Officer Assessment Report PA2302600

104 Reema Boulevard, ENDEAVOR HILLS VIC 3802

Officer Assessment Report
Development Approvals & Design

Department
of Transport
and Planning

Figure 4: showing neighbouring dwellings to the north

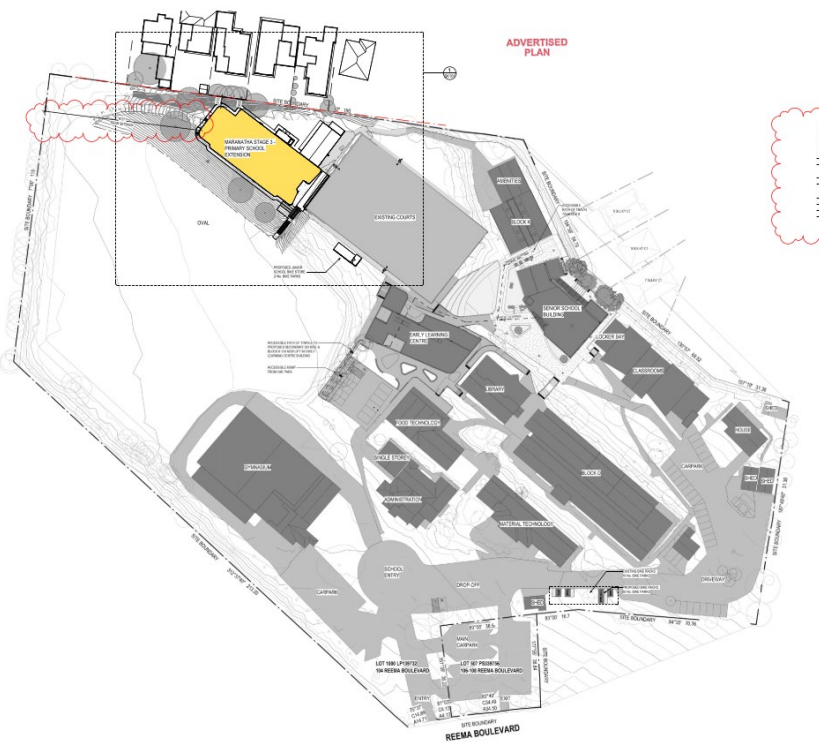
7. Of particular note, is the lots with dwellings located to the north of the new building including 9, 8, 7, 6 and 5 Pinto Close. These dwellings have rear private open spaces which abut the boundary shared with the school. The closest point of the new building is setback 3.7m from the northern boundary and all windows along this new building façade have sill heights of 1.83m above finished floor level. See figure below.

Figure 8: proposed landscaping plan showing vegetation to the northern boundary

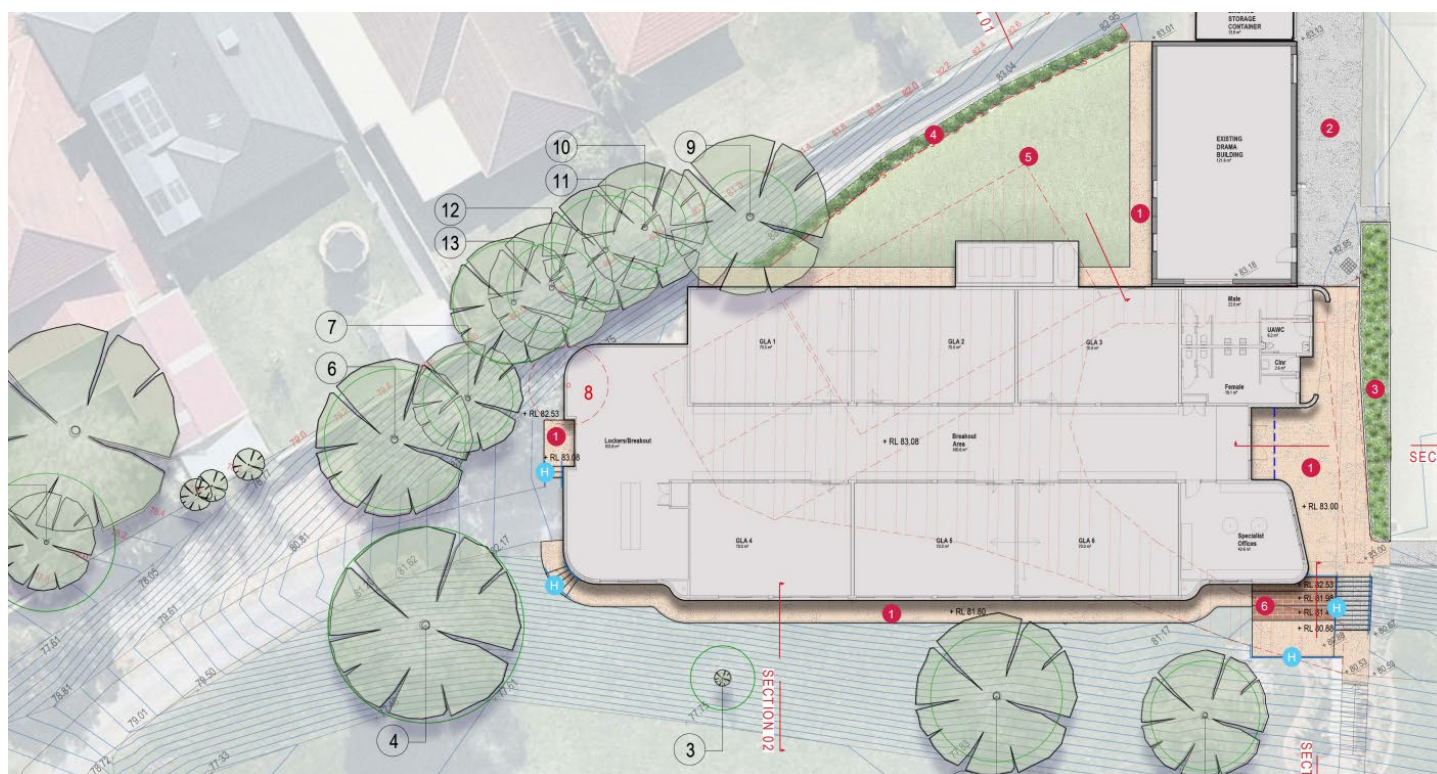
dwelling to the north due to the slope of the land, the setback of the building 3.7m from the common boundary, combined with the existing mature trees along this common boundary, will assist with softening the built form. The views from the rear private open spaces of the dwellings along Pinto Close will remain of existing trees and enhanced by proposed additional landscaping along this boundary.

38. The proposal includes works to the land for a new pedestrian path to the building and an extension to the existing staircase to allow external entry into the building. This staircase and southern path appropriately provide for logical pedestrian flow to and from the new building and sports field, at the furthest distance from the residential interface to the north.

60. Casey City Council's landscape department have reviewed the Arborist Report and plans and are supportive of the tree removal and require a Tree Management and Tree Protection Plan to be provided for trees 1-7 and 9-13 as conditions of permit. The Council has also recommended that the landscape plan be amended to address matters such as a planting schedule. All of the Council's recommended conditions will be included on the permit.
61. The proposal is consistent with objectives and strategies at clause 22.02-4 in that existing vegetation is retained where practicable and a landscape strip width of at least 2m (specifically, 3.7m) is provided to the nearest property boundary to screen adjoining properties.
62. Overall, the proposed tree removal and landscape response is considered acceptable, subject to the inclusion of Council's conditions.

Figure 9: sections of the site setback (source applicants submission)

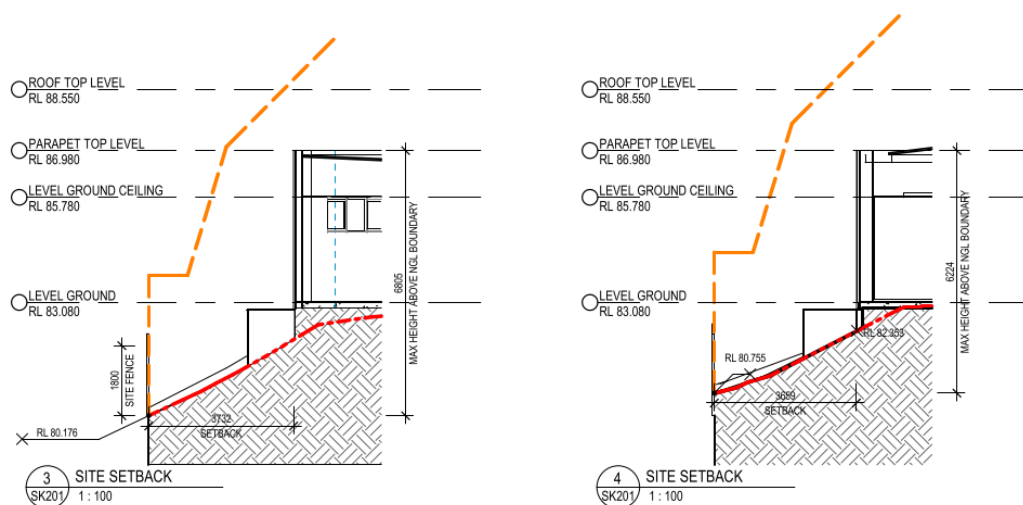
39. When considering side setbacks and building heights, Clauses 54 and 55 of the Casey Planning Scheme provide some guidance on an appropriate building envelope. The proposed new building is appropriately setback from the nearest (northern) site boundaries with a setback of 3.6m-3.7m. These setbacks along with the topography and stepping-up of the land results in part of the building appearing larger than a single storey dwelling. However, it's noted that the building complies with the B17 side setbacks nominated in Clauses 54 and 55 of the Casey Planning Scheme. See sections below.

40. Overall, the modest building height, setbacks and landscaping treatment to the northern residential interface provide an appropriate response to the amenity and neighbourhood character of the area.
41. The architectural style, with a flat roof with a pop up section with windows, a mixed materials and finishes palette and large window openings to the south will provide a contemporary building that is compatible with other buildings on the school site.
42. The proposal is consistent with planning policy which acknowledges that new educational buildings are different to dwellings (including material, height, scale and mass).
